UNITED STATES PATENT AND TRADEMARK OFFICE

APPLICATION NO.	FILING DATE	FIRST NAMED INVENTOR	ATTORNEY DOCKET NO.	CONFIRMATION NO.
09/868,938	07/18/2001	Kiyoshi Nishio		4331

Office Action Summary

FINAL ACTION

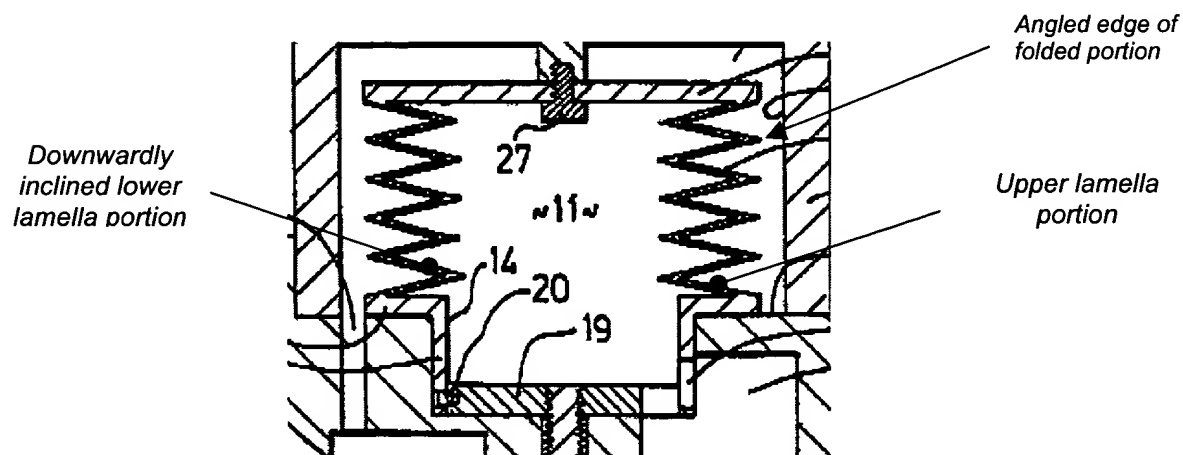
4. Claims 7 and 10 are rejected under 35 U.S.C. 103(a) as being unpatentable over Hope et al. (4,231,724) in view of Boedecker et al. Hope et al. teach a fluid apparatus having a bellows 45 configured by a pump in which a bellows that has an extending and contracting portion configured by forming ridge-like folds and valley-like folds in a vertically alternate and continuous manner (see column 5, lines 7-13), and that is extendingly and contractingly deformable in an axial direction. The bellows 45 are placed in a main frame 12 (corresponding to the claimed pump body) such that the axial direction extends along a vertical axis, and include a chamber inside of the bellows. Hope et al. further teach a suction port 83 and a discharge port 63 and that the extending and contracting portion of the bellows is formed into a shape in which a lower one of upper and lower lamella portions of each of the ridge-like folds is downward inclined toward the vertical axis, in both the extending and contracting state (see the accompanying figure), and the edges of the folded portion are angled. With regards to

claim 10, since the bellows are exposed to air, it stands to reason that there is an air chamber outside of the bellows. That is, outside of the bellows 4 and within main frame 12, constitutes the claimed air chamber.

While Hope et al. teach most of the limitations of the claims, they do not explicitly teach that the ports are in an inner bottom face of the pump body facing the liquid chamber. It would have been obvious to one of ordinary skill in the art at the time the invention was made to include the ports in an inner bottom face of the pump body in order to advantageously reduce the number of elements in the fluid apparatus. By reducing the number of elements, the cost of the apparatus and the manufacturing times may be reduced. Further, it would reduce the overall height and weight of the apparatus by incorporating the ports in the pump body.

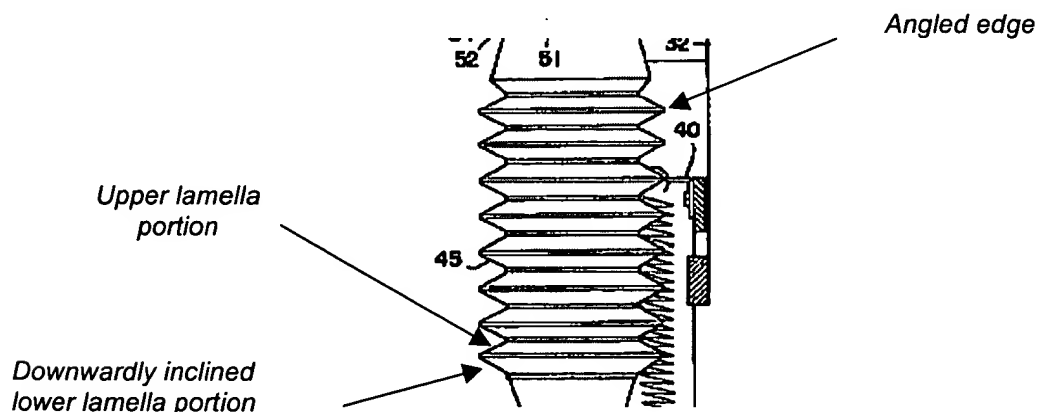
3. Claims 7 and 10 are rejected under 35 U.S.C. 103(a) as being unpatentable over Thomin et al. (WO 99/31388) in view of Boedecker et al. (4,655,690). Thomin et al. teach a fluid apparatus having a bellows 12 with extending and contracting portions configured by forming ridge-like folds and valley-like folds 18 in a vertically alternate and continuous manner, that are extendingly and contractingly deformable in an axial direction. The bellows are placed in a pump body 1 such that the axial direction defines a vertical axis. Figure 2 illustrates an inner pumping chamber 11 (corresponding to the claimed liquid chamber) formed inside of bellows 12; an outer pumping chamber 10 (corresponding to the claimed air chamber) formed outside of the bellows 12; and a

suction (or inflow, as in claim 4) port 43 and a discharge (or outflow, as in claim 4) port 45 formed in an inner bottom face of the pump body facing the inner pumping chamber. Figure 2 further illustrates that the bellows are formed into a shape in which a lower one of upper and lower lamella portions of each of the ridge-like folds is downwardly inclined toward the vertical axis, in both the extending and contracting state (see the accompanying figure), and the edges of the folded portion are angled.

While Thomin et al. teach most of the limitations of the claims, they do not explicitly teach that the bellows can be made of polytetrafluoroethylene. Boedecker et al. teach using a "flexible plastic which is resistant to chemicals, preferably polytetrafluoroethylene" (see column 2, lines 28-30). Therefore, it would have been

obvious to one of ordinary skill in the art at the time the invention was made to use a plastic bellows made of polytetrafluoroethylene, as taught in the Boedecker et al. invention, in the Thomin et al. invention in those cases where caustic fluid is to be pumped in a piping in order not to damage the bellows.
